## **Breakwater at Newcastle**

**[ Alexander McLeay, Colonial Secretary to Mitchell ]**

N° 33/137

*p277: Breakwater at Newcastle ( pencil annotation: Fig 3)(this image has been cropped to remove the backing page and glue marks)*

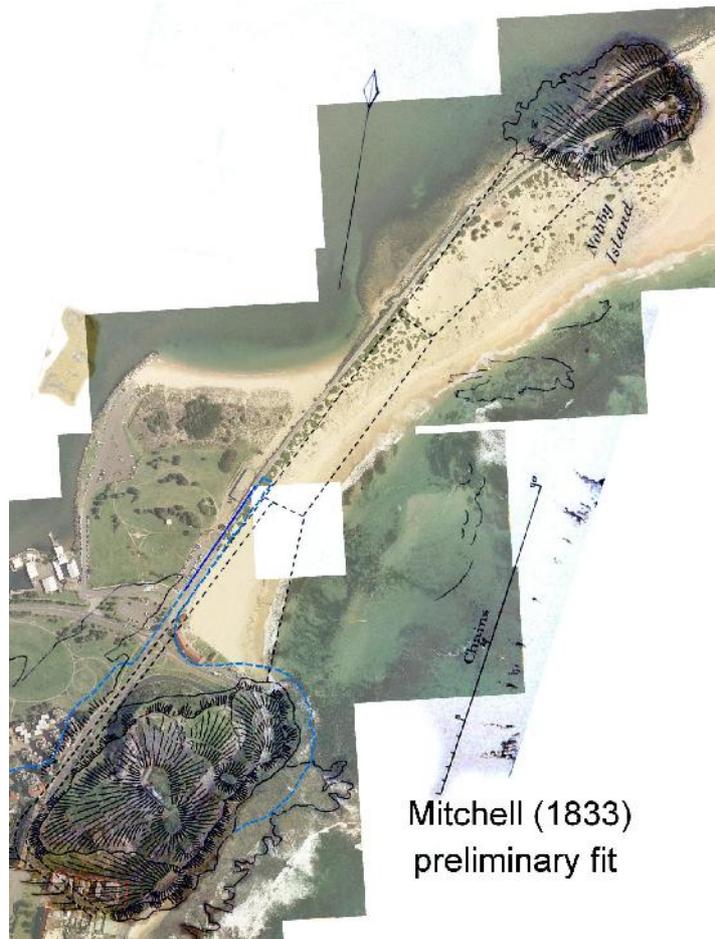
might be perhaps advisable in this country, with our present means, to adopt some plan requiring less art and ingenuity, but more manual labor [sic], such as for instance the extension of a dyke of stones thrown in either loosely or in caissons, in the direction of (ABCD) to nearly the height of high water mark, when the space it enclosed would probably soon filled with sand, or if not, might be filled with ravel: a similar dyke (BE) might be extended to the mainland, by which the space outside the present Breakwater would be filled by the like sediment from the dead water, and on extending two similar dykes to Nobby the whole would probably form a neck of sand connecting the Island to the main, in the same manner as Baranjuey, a rock very like Nobby, in shape and position, is joined to the South Head of Broken Bay. The sea [p278] would probably throw up sand into the curve or Bay thus made, and form a beach similar and analogous to that immediately East of the Town of Newcastle, where hills of heterogeneous sand shew that this little Bay was also at one time a mouth or outlet of the Hunter.

If the Nobby were joined to the point by any means sufficient to separate the waters even temporarily, I am of the opinion that the sea would throw up a beach of sand which might assist materially in preserving the work, and completing the reunion of Nobby to the land. It seems to me therefore to deserve consideration, with reference to the means at the disposal of Government, whether the present breakwater should be extended to Nobby, according to the best mode of construction, disposing the gravel or discharged ballast, before the part now standing, for its preservation; or to carry on the work somewhat in the same manner in which it has been commenced, throwing the ballast from shipping in the face of it to protect the structure from the waves, (in which case also a sandy beach might be formed by the sea, and afford additional protection), or whether, finally, it would be expedient to restore the natural structure more exactly by the dykes I have proposed, and rely on the co-operation of the sea. As a work for the immediate employment of the prisoners now at Newcastle, I would recommend the removal of the stones and gravel accumulated about the wharf and Harbour, to the front of the present Breakwater, this being most
